Proposal Request

Project:
Intermountain Healthcare Lake Park Level 1 Remodel
2545 College Drive
Murray, Utah 84123

Date: 02/11/2021
Proposal Request
PR # 01

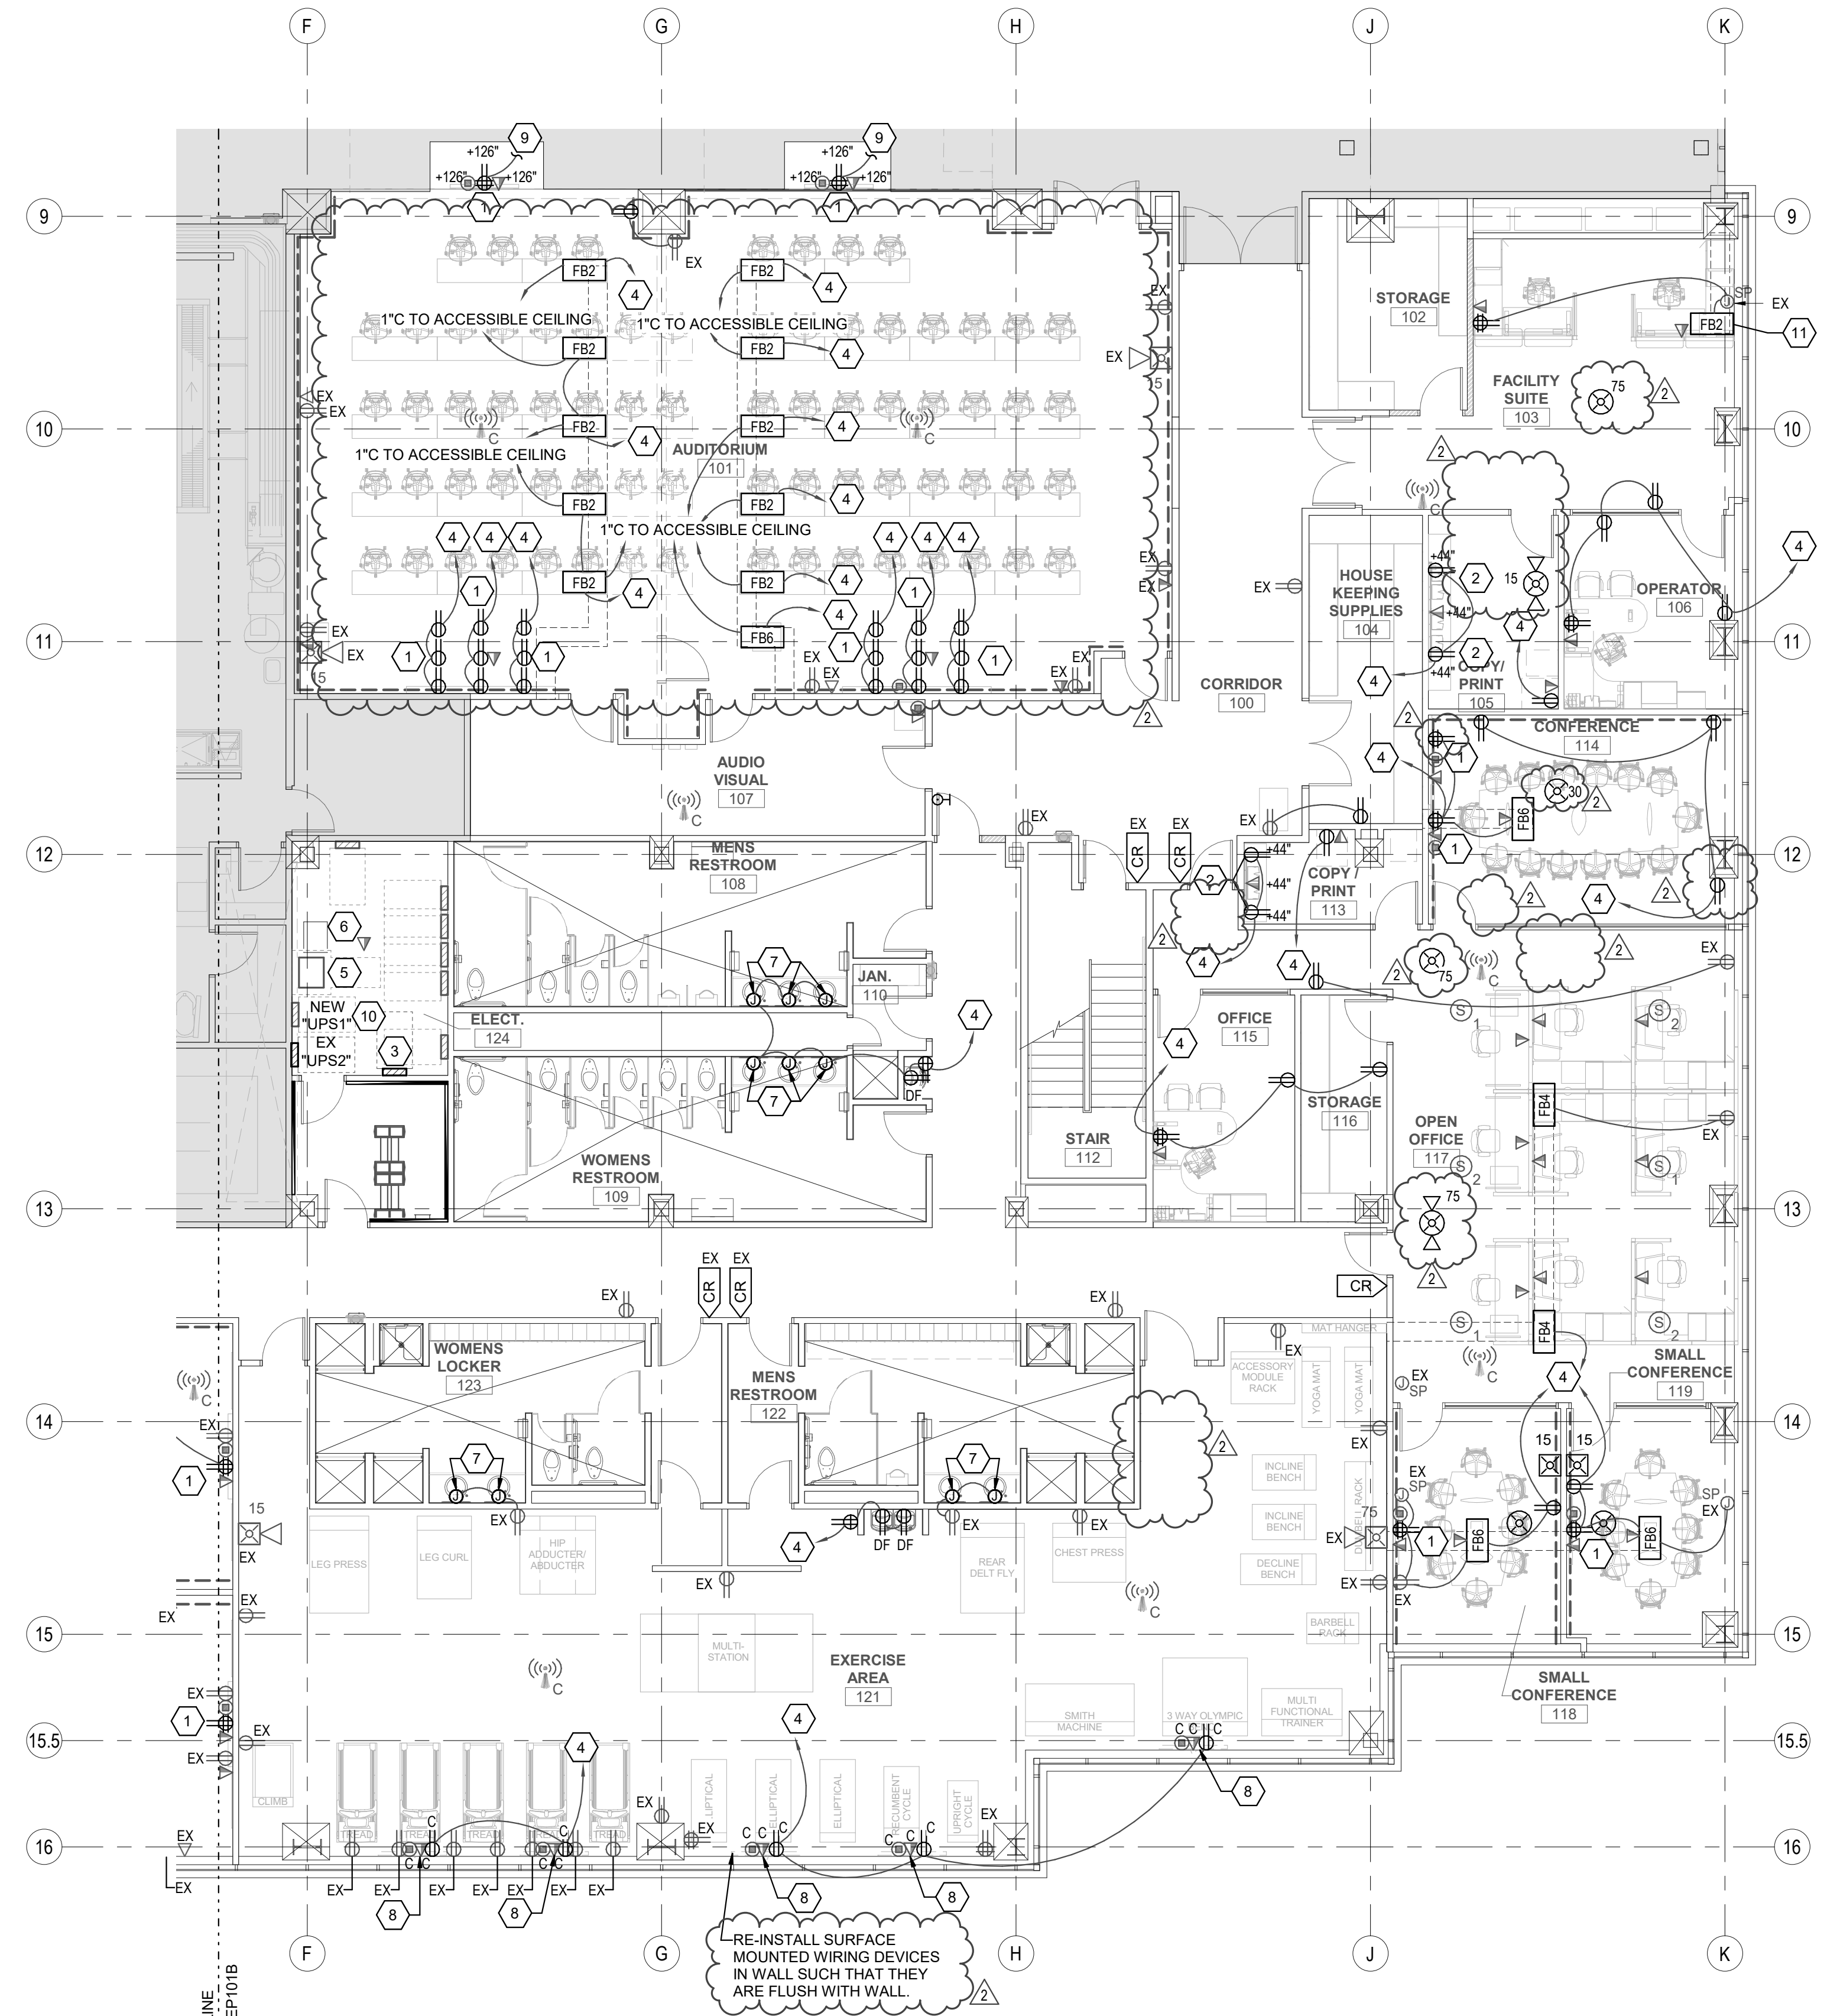
- Sewer District Comments:** During the city plan review process, we were required to submit to the sewer district. The sewer district required us to include some notes to specific sheets. See the revised. The owner's group requested the extension of the existing Data room walls to go to deck. This resulted in the elimination of the existing ceiling and lighting, which caused the addition of new wall mounted lights and relocation of the new mechanical grilles. See the Mechanical Narrative, and the revised PP101, and PP401.

SHEET - PP401 –PLUMBING ENLARGED RESTROOM PLAN

1. Keyed notes 13-15 added to drawings.

<p>SHEET DESCRIPTION: LEVEL 1 LIGHTING PLAN - AREA B</p>	<p>SHEET: EL151B</p>
---	---------------------------------

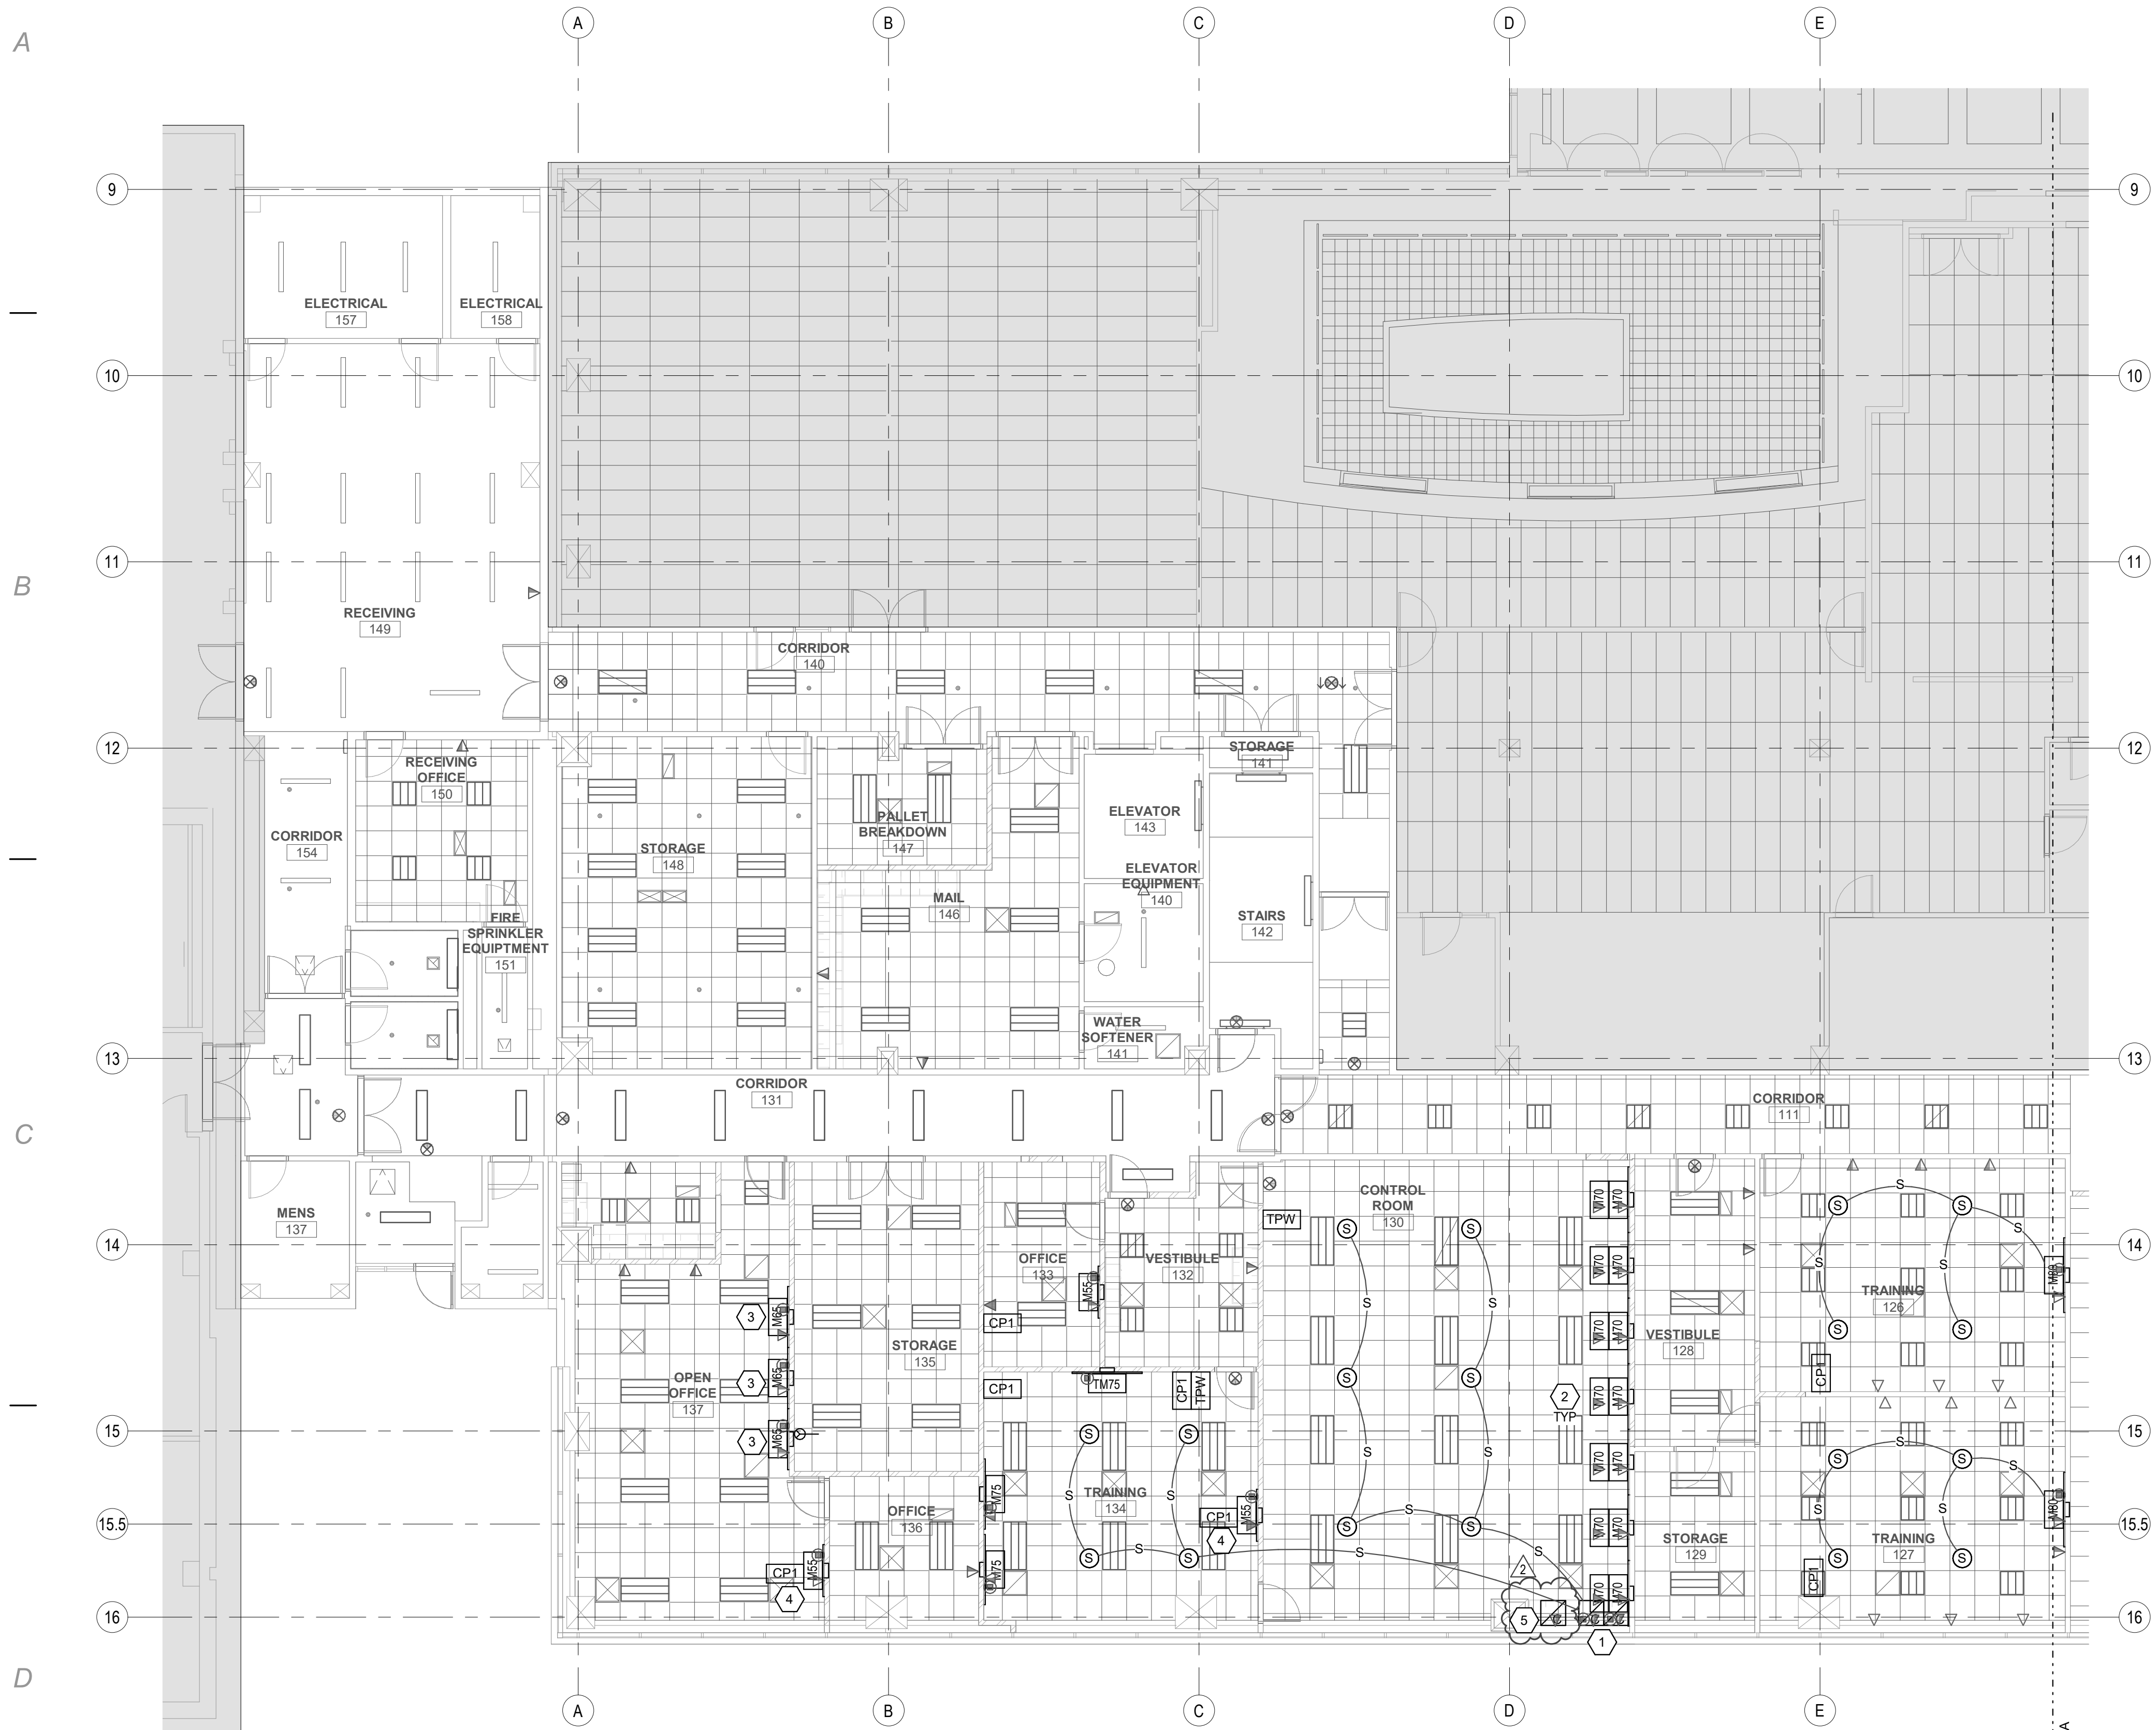
5. **Door Modifications:** In coordination with the Contractor, there are several door frames that will now be left in place. Their frame designations in the door schedule have been modified to indicate existing. This applies specifically to doors: 125, 139, 141, 149, 149a, and 150. The Contractor shall verify all door frame prep required for the new conditions to determine if the existing frame can be reused. The Contractor shall verify, patch and repair the frame to assure that it will ultimately be in like new condition upon completion. Door 131a's swing has been modified to match existing conditions. Additionally, per Owner request, Door 131a has been removed from the scope of the project. The existing door needs to be painted and adjusted to be in like new condition. Please provide the applicable credits. Additionally, per Owner request Door 121 has been enlarged to 3'-6" to allow for larger by gym equipment, which required the modification of adjacent walls and ceiling. See the revised AD101, A101, A101A, A101B, A151, A601, A1101, and EL151.

7. **Electrical Modifications:** The following are primarily per Owner request: existing outlets that run in exposed conduit along the south wall in the exercise area need to be rerun within the exterior framed wall. Provide the electrical, and drywall work to make the modification. Additionally, it was discovered by the Contractor that various electrical devices were shown in locations that would be difficult or impossible to install, therefore Conference Room 114 has been modified. Additionally, per RFI #04 two monitors are needed for the West wall with supporting electrical devices. Per Owner Requests, the fire alarm strobes have been changed from wall mounted devices to ceiling mounted to match existing. The floor box type in Training Room 134 has been modified to allow the data connections to be within the floor box. Modifications to the power have been made to Storage 135. A fourplex and data were removed from Exercise room 121. Additional data ports were added to Control Room 130, Training 134, and Office 133. These data ports are to terminate in the West end of the cabinet within Control Room 130 in a new IT rack (EJ101B), which modified the cabinet slightly. A ladder rack was added to DATA 125. Updated data device schedule on ET501 and Telecom Cable Riser Diagram on ET601. Light switches have been removed from corridors. See the attached Electrical Engineer Narrative for ET Sheet changes, and the revised A252, A551, AP101, EP101A, EP101B, EP602, EL151A, EL151B, ET101A, ET101B, ET501, and ET601.
